Service Bulletin No. 044

TO: Service Managers
FROM: Joe Blackwell
DATE: October 18, 1993
RE: Last Action Hero/Jurassic Park - Flipper Return Springs

(Figure 1)

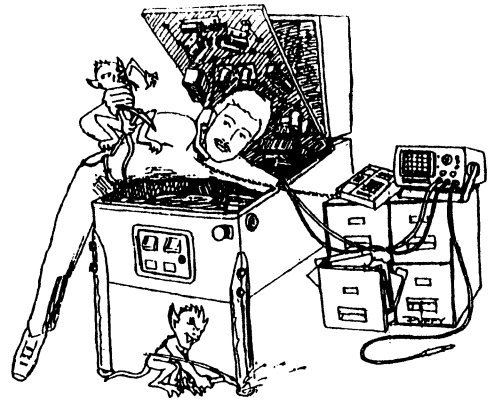
Symptom: When flipper is energized it does not return to its rest position after releasing the flipper button.

Problem: Flipper return spring has broken off the spring bracket (FIG. 1). We have found a number of these machines which have had the end of the spring crimped to the spring bracket to secure it from popping off. This is not necessary and will cause premature spring failure.

Solution: Replace spring (Part No.: 265-5029-02). This is not a modified spring, it is an exact replacement part without the crimp.
